BUILDING PERMIT

Site Address: 3188 SEABRIGHT DR
Unit NO:
Description: RESIDENTIAL SECOND UNIT IN THE BASEMENT WITH ABOVE GRADE SIDE ENTRANCE, FINISHED BASEMENT AREA FOR PRINCIPAL RESIDENCE
Date Issued: 2023-11-20

Project: PROPOSED BASEMENT FINISH PLAN FOR 2ND DWELLING UNIT AT 3188 SEABRIGHT DRIVE, MISSISSAUGA, ONT. L5M 0B4
Owners: RAIS KAMRAN, KAMRAN BEENA

1 SITE PLAN
A1.0 SCALE= 1:125

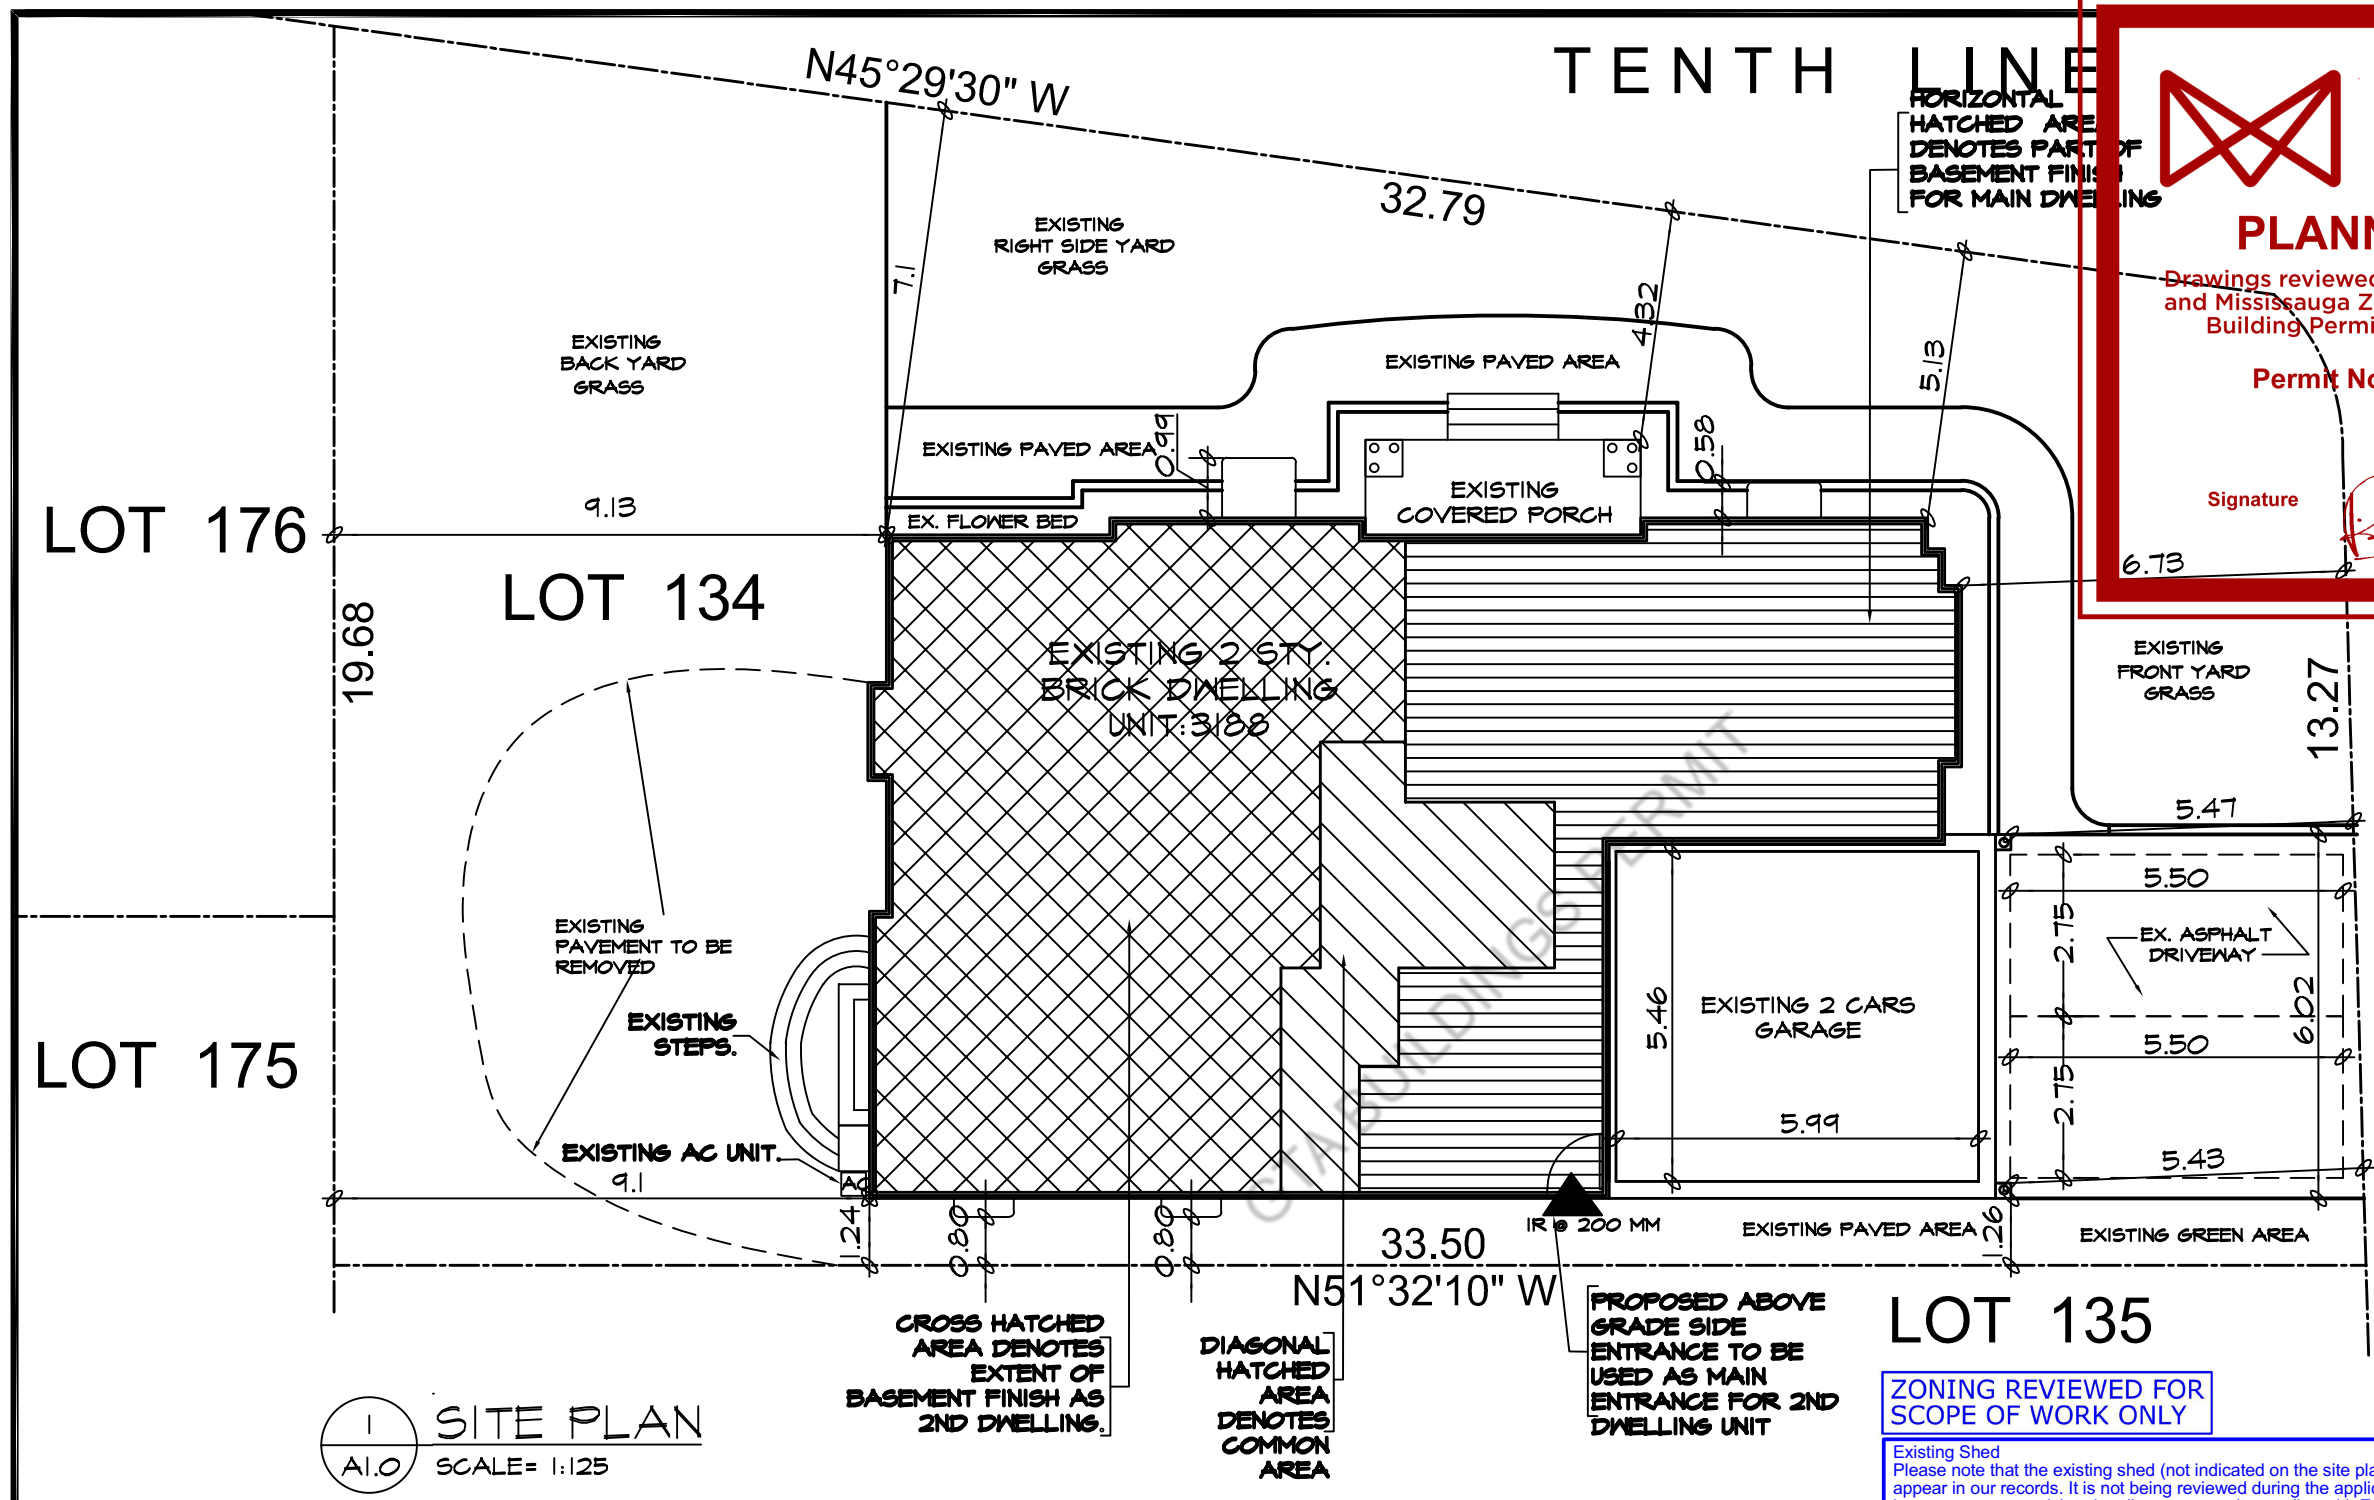
ZONING REVIEWED FOR SCOPE OF WORK ONLY
Existing Shed
Please note that the existing shed (not indicated on the site plan) does not appear in our records. It is not being reviewed during the application permit, however you may wish to legalize or ensure it complies with Zoning Regulations 4.1.2 in Zoning By-law 0225-2007.
